August 12, 2008

SUBJECT: SALEM NUCLEAR GENERATING STATION UNITS 1 AND 2: REPORT ON RESULTS OF STAFF AUDIT OF CORRECTIVE ACTIONS TO ADDRESS GENERIC LETTER 2004-02 (TAC NOS. MC4712 AND MC4713)

Docket Nos. 50-272 and 50-311

Figure 3.6-1 CCI Test Loop

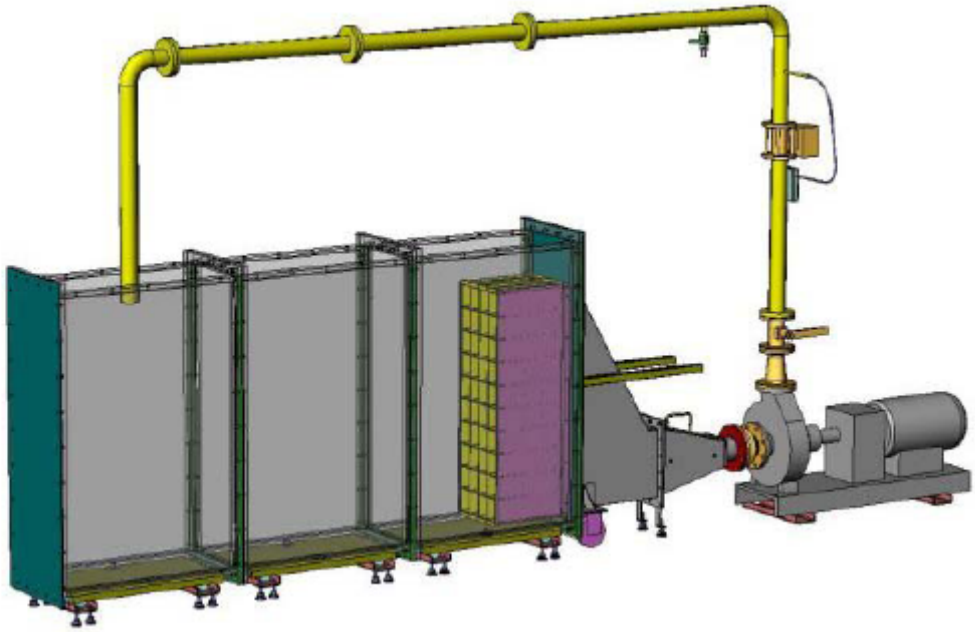
Prototypical head loss testing was performed for the licensee by the strainer vendor following their testing procedures. The only testing evaluated in this report is the testing that was performed in the multifunctional test loop (Figure 3.6-1) because that is the testing that the licensee used to evaluate the strainer head loss performance. Prior to conducting testing in the multifunctional test loop, both large- and small-scale head loss tests, using strainer modules with different numbers and arrangements of pockets, were conducted in different test facilities to

Test 2a was a repeat of Test 2, except that a plate was installed in the test flume with an 8 mm gap between the plate and the side wall of the flume. Although not shown in Figure 3.6-1, this plate can be seen in Figure 3.6-2 upstream of the strainer module. The plate is installed and a small gap is maintained between the vertical side of the tank and the edge of the plate. All flow is forced through this gap resulting in increased turbulence in the tank and increased flow parallel to the face of the strainer, upstream of the strainer module. The gap introduced enough turbulence into the tank that debris settlement was minimal. This test was run for about two hours after the last debris addition, allowing about 15 tank turnovers. However, the peak head loss of 8.3 ft occurred about one hour after the last debris batch was added. Immediately following the last addition, the head loss decreased quickly to about 7.2 ft and then drifted down slowly to a head loss of 6.9 ft at test termination. It is likely that the rapid decrease in head loss was due to channeling or bore-hole formation initiated by the high differential pressure. The licensee noted that with higher turbulence and, therefore, higher transport, the peak head loss value increased before the theorized channeling/bore-hole phenomena occurred.

Figure 3.6-2 CCI Test Loop for Future Tests

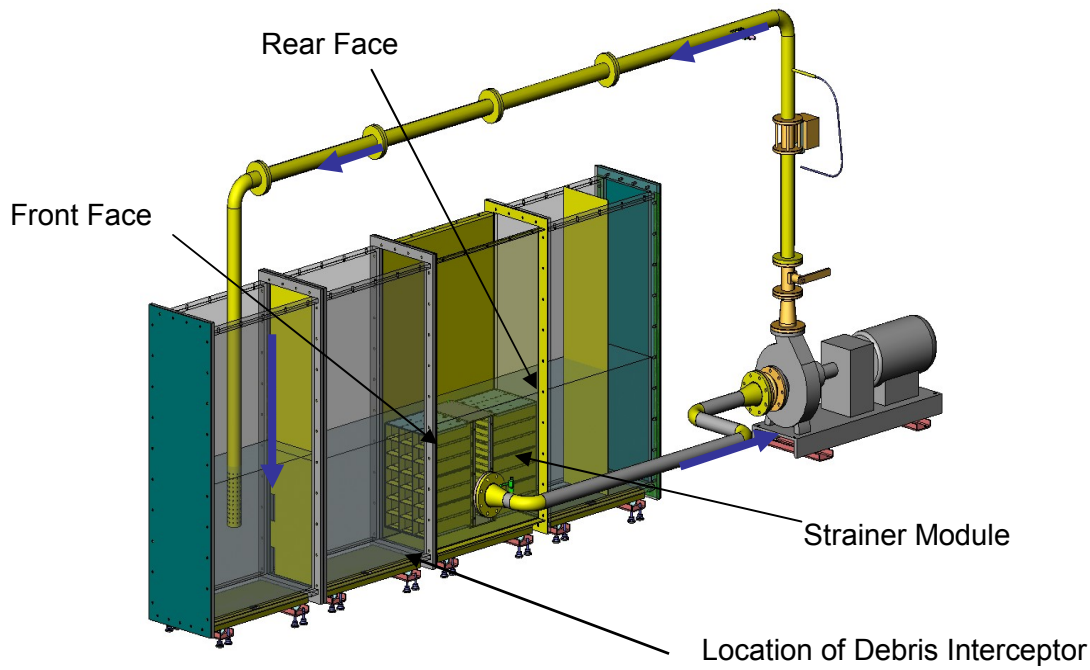
- The test mock up did not include the back side of the strainer--the side facing the outer containment wall. (See Figure 3.6-2 for a conceptual test set up with this configuration.) The back side of the strainer would likely benefit from significant settling with the front side acting as a debris interceptor.

proceeding with a new testing program that will provide a test setup that is more prototypical of the plant arrangement (Figure 3.6-2). A final evaluation of the acceptability of the head loss for Salem cannot be completed by the staff until the testing is completed and a finalized head loss calculation is provided for review. The need for the licensee to provide the results of the updated head loss testing and the associated finalized head loss calculation is designated as **Open Item 3.6-1** and is presented in detail in Section 3.6.6.
